TOWN OF WESTON COMMUNITY PRESERVATION COMMITTEE
Project Submission Form – FY17

As the School Department undertakes the renovation of the case House, the WHC wishes to fund portions of the architectural planning related solely to issues of restoration and/or historic preservation

Weston Historical Commission: Historical and Architectural Restoration of the Case House

School Administration Building
 CASE HOUSE
 Existing Conditions Study
 Weston, Massachusetts

Title:
 EXISTING CONDITIONS
 FLOOR PLAN
 GROUND

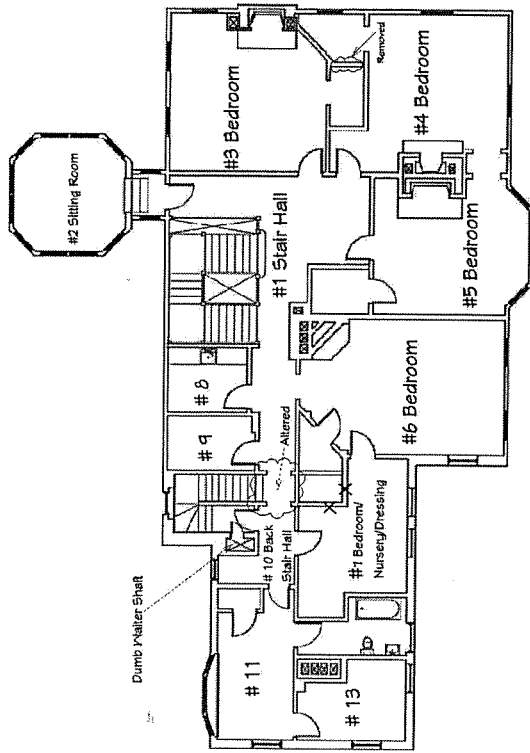
- All of entrance and stair hall, and stair case, with large fireplace (#1 on marked up drawing)
- (Note: missing porte-cochere outside of east entrance)
- All Rooms with fireplaces (#2,3,4)
- Original Half-Bathroom (#8)

2. **First floor public areas:** Restoration of the original layout and detailing including the following;
 - Stair Hall; at the south door wall; strip off paint and restore the original oak wall and door trim. (All of Stair Hall; the oak ceiling planking, as well as the exposed hewn oak floor beams, probably originally had a clear finish. Even if it is determined that the original finish was clear, maybe stripping these is not a high priority).

- Removal of the carpet from the tile floor of the Entrance Hall (#1) and restoration of the tile.
 - Restoration of the Parlor (#2) and the Library (#3) to their original layout and of their original paneling, trim, cornices etc. and reproduction of the original doors and doorways between them. Note current replacement door from Hall to Library; it is not oak (poplar, gum) and not a match to the original. Should be replaced with replica door in quartered/rift oak. *(More research needed to try and determine how the two rooms were connected. The trim, paneling etc. can be extrapolated from what is there).*

- Removal of all dropped ceilings and restoration of ceiling and crown moldings etc.
 - Restoration of the wall and the doors between the Dining Room (#4) and the Stair Hall (#1). It appears that the original wall was double thickness which would indicate that pocket doors connected the two spaces, probably lined up with the grand Stair Hall fireplace. *(More research is needed to try and determine how the two rooms were connected. The trim, paneling etc. can be extrapolated from what is there).* Included in the Dining Room restoration is to remove the doorway that was crudely punched through the wall to connect to the 50s addition. Restore the paneling there. Strip and refinish the built-in Dining Room hutch and surrounding trim.

- Restore, including the vintage fixtures, the old half-bath off the Stair Hall (#8)
 - Repair all woodwork as needed and refinish as needed.
 - Sand and refinish all wood floors

Title:
EXISTING CONDITIONS
FLOOR PLAN
SECOND

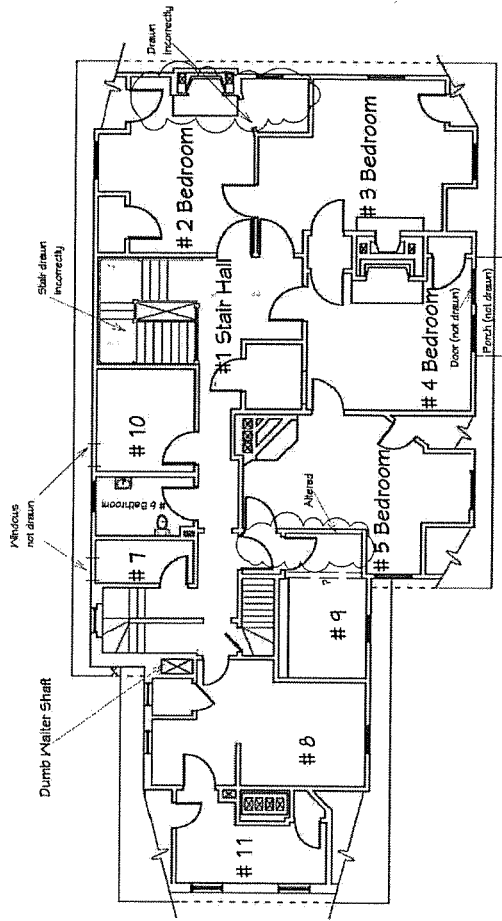
- Stair Hall up to doorway at back stair hall
- All rooms with fireplaces (#3,4,5,6)
- Eight-sided Sitting Room (#2)

3. **Eight-sided sitting Room** off second floor stair hall (#2); The original (probably) quilted mahogany paneling, moldings, trim and brackets are in very good shape, as are the plastered surfaces, other than some water staining. The whole of the walls, window surrounds and ceiling need very careful refinishing. The floor is covered in w/w carpet which should be removed and the floor under restored (replicated if missing). *The toughest challenges for this room are introducing insulation and mechanical systems without destroying the historical fabric, and the issue of accessibility. The latter may require some sort of variance and/or dispensation from the state.* It is WHC's opinion that this room needs extraordinary attention and effort at restoration: very special and very unusual.
